City of Portsmouth Planning Board

Property Address: 238 Austin St.

Application #: LU-25-177

238 Austin St
Subdivision Application
Project Description

TITLE
SITE PLAN
238 AUSTIN ST
PORTSMOUTH, NH 03801
TAX MAP 135, LOT 61

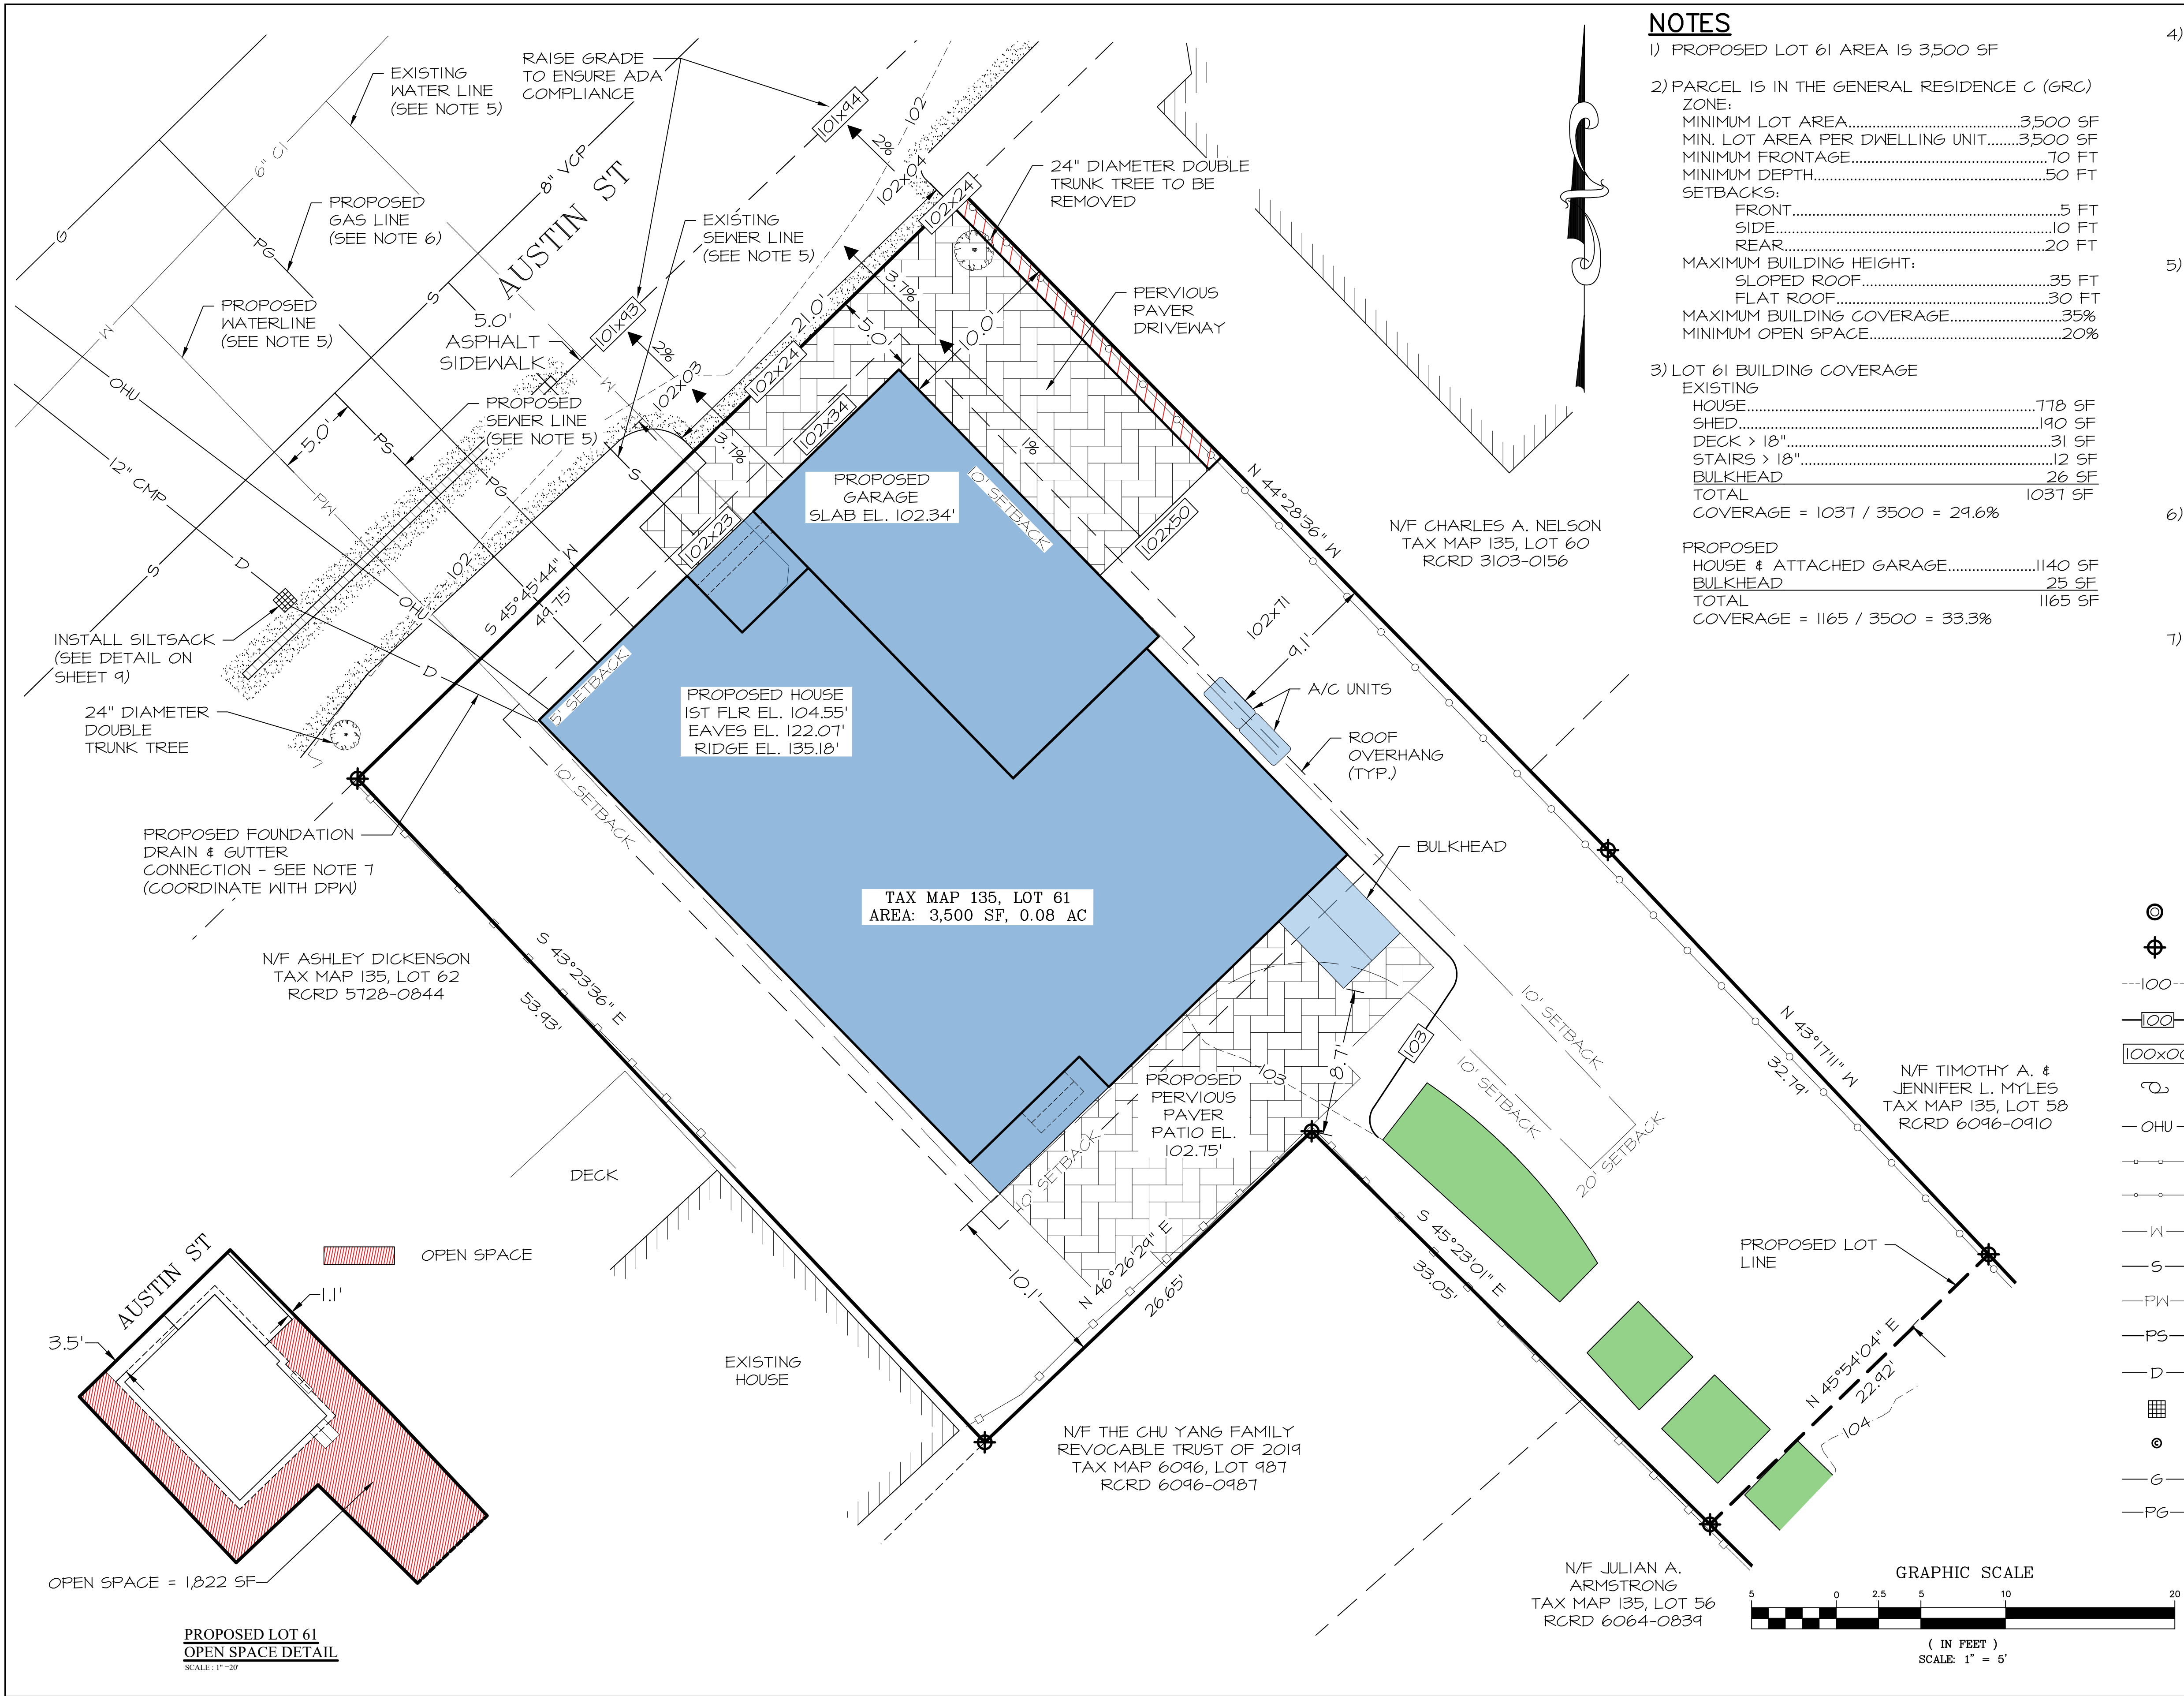
2. *Show all existing utility connections and clearly call them out for abandonment if applicable.*

- EXISTING WATER AND SEWER SHALL BE ABANDONED OUTSIDE THE FOOTPRINT OF THE PROPOSED BUILDING PRIOR TO THE DEMOLITION OF THE EXISTING STRUCTURE. THESE LINES SHALL BE CUT AND CAPPED AT THE MAINS WHILE INSTALLING THE PROPOSED WATER AND SEWER.

The connections have been shown and both note 7 on drawing 2 and note 5 on drawing 3 calls for abandoning of lines.
